Dam Visual Inspection/Evaluation Report

Cherry Valley Pond Dam

Glocester, Rhode Island

Inspector: *Thomas Fitzpatrick (DEM)*
Date of Inspection: *November 9, 2022*

Photo 3: Upstream embankment and crest as viewed from left of the primary spillway looking right.

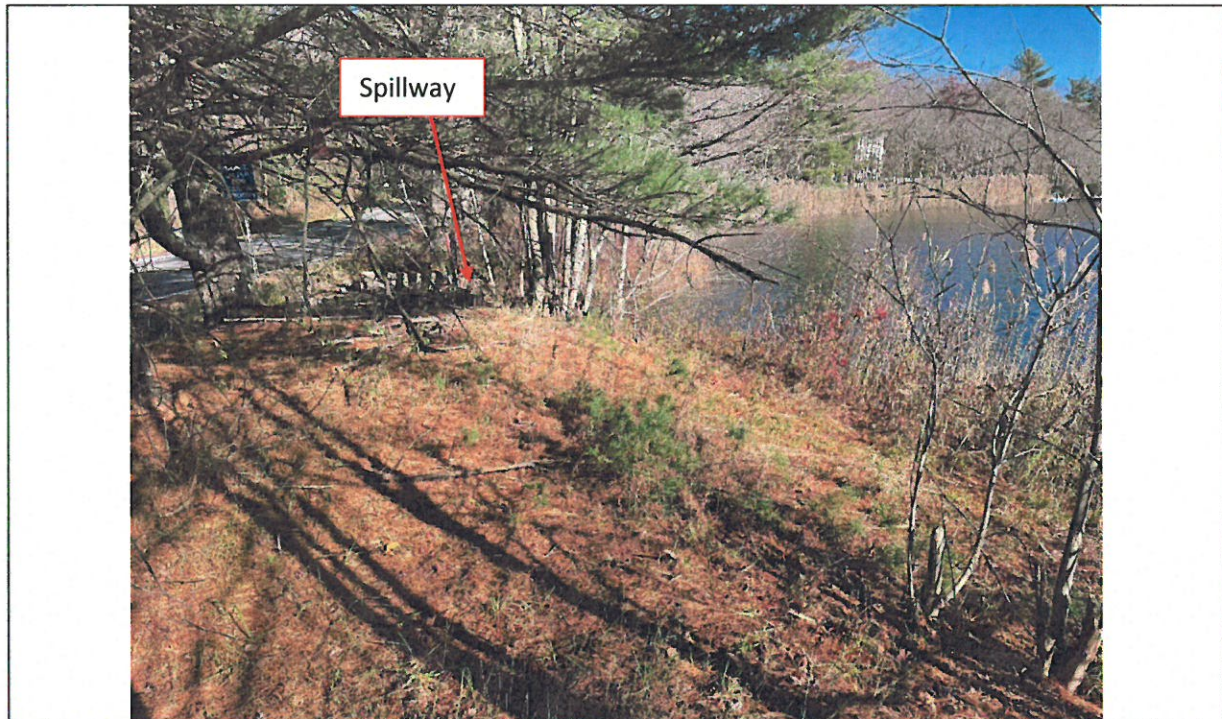
- The upstream embankment consists of an earthen slope partially overgrown with vegetation, leaf litter, and large trees (Photos 2-6).
 - Vegetation, reed growth, saplings, and pine/leaf litter were thick in some areas.
 - Large trees (>30 inches in diameter) are growing between the impoundment and drainage swale.
- The slope is irregular, with variable alignment.
- There is no waterline erosion protection. Minor scarping is typical along the waterline.
 - Scarping has resulted in 12 inch vertical faces along the waterline.
 - Scarping on the right side of the spillway training wall has cut approximately 8 inches into the embankment (Photo 12).
- No animal burrows, sinkholes, or slumps were noted.

Irregularities Noted: The upstream embankment has irregular alignment, minor scarping at the waterline, vegetation, leaf/pine litter, and large trees on the embankment.

1. Remove the trees from the upstream embankment and downstream toe of slope in accordance with Rule 10(A) (1) of the Rules and Regulations for Dam Safety.
2. Remove the vegetation and leaf litter along the upstream and downstream embankments and within the discharge channel to 15 feet beyond toe of slope. Inspect these areas for any deficiencies and refer to a professional engineer for appropriate corrective measures.
3. Install erosion protection/armoring along the upstream embankment to prevent future scarping at the waterline.
4. Have owners remove all debris accumulating on the spillway weir, within the drop inlet, and in the culvert. Have owner regularly schedule debris clearing to prevent blockages.
5. Have owner's engineer assess the condition of the undermined section of culvert/wingwall and make recommendations.

Photo 4: View of the dam crest and embankment from the primary spillway looking right. Note the drainage swale slopes into the back of the primary spillway (blue).

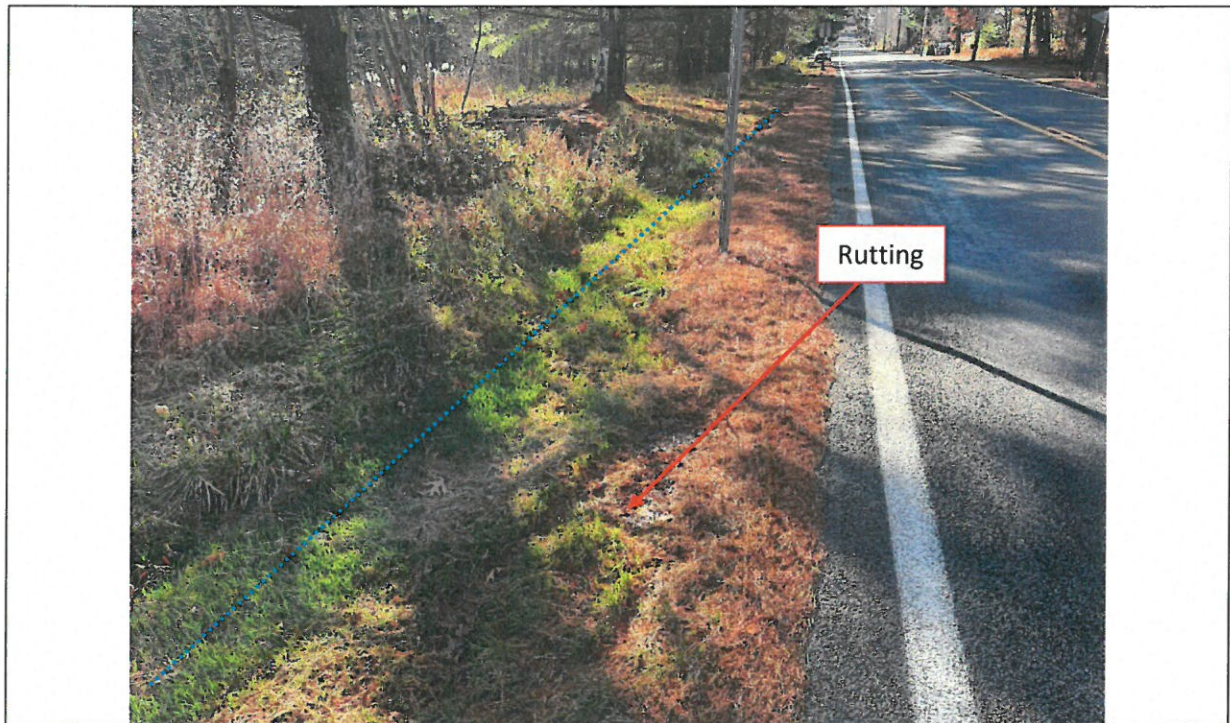
Irregularities Noted: The upstream shoulder of the road is an irregular swale that flows into the primary spillway drop inlet. Minor rutting is present near the swale.

Photo 10: View of the spillway discharge channel (blue) from atop the downstream private road looking upstream. The downstream toe of slope is shown in red.

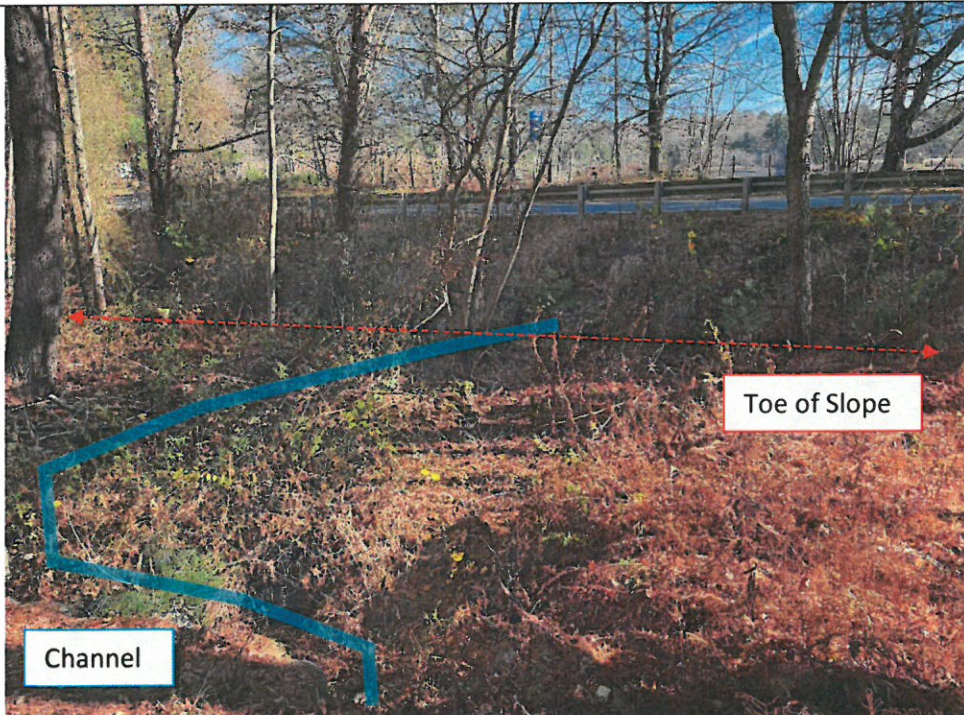
Irregularities Noted: Some debris is accumulating on the weir, in the culvert, and in the spillway discharge channel. Vegetation in the discharge channel would reduce spillway discharge capacity.

1. Clear vegetation and have owner's engineer inspect areas.
2. Remove debris impacting the capacity at the spillway drop chamber and culvert.
3. Remove vegetation at the spillway discharge channel to 15 feet beyond the toe of slope.

Photo 15: View of the primary spillway discharge outlet and wingwalls. Note the encroaching vegetation that would reduce spillway discharge capacity.

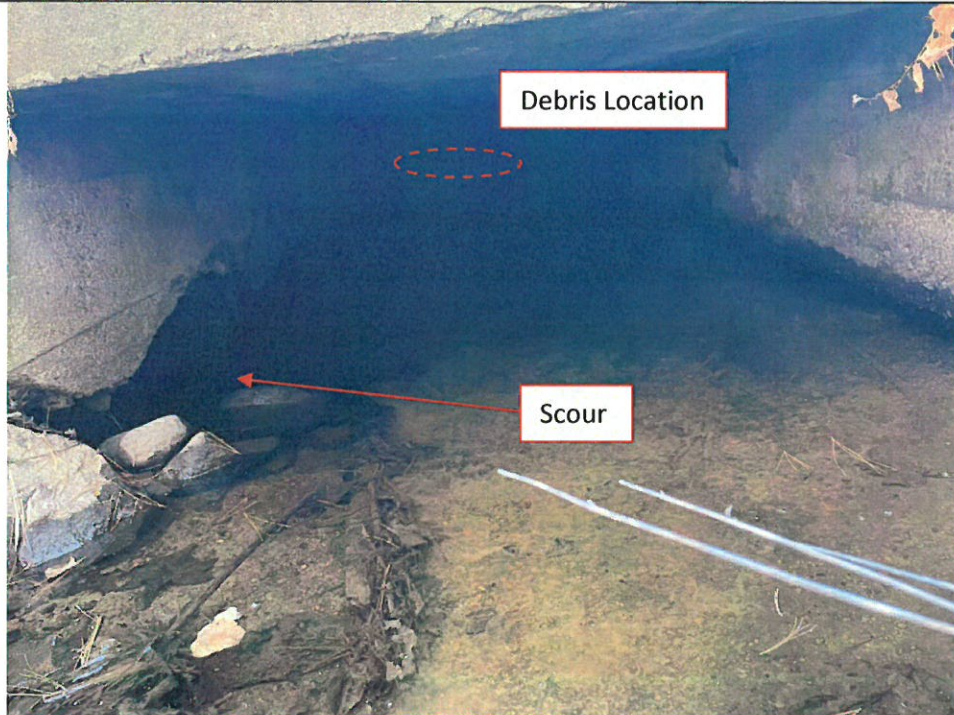
- Where the culvert meets the right downstream wingwall, the bottom section of the culvert has scoured/broken away (Photos 15-16).
- The downstream headwall and wingwalls have good alignment.
 - The right wingwall is undermined at least one foot but shows no signs of movement at this time.
- The discharge channel is overgrown with trees, briars, and vegetation which will impact capacity.
 - No energy dissipaters were noted in the downstream channel.
 - Roughly 50 feet downstream of the primary spillway discharge headwall the channel leads to a stone masonry culvert which exits under a private road (Photo 14).
 - Debris in the channel may block this channel in the event of a significant flood event.
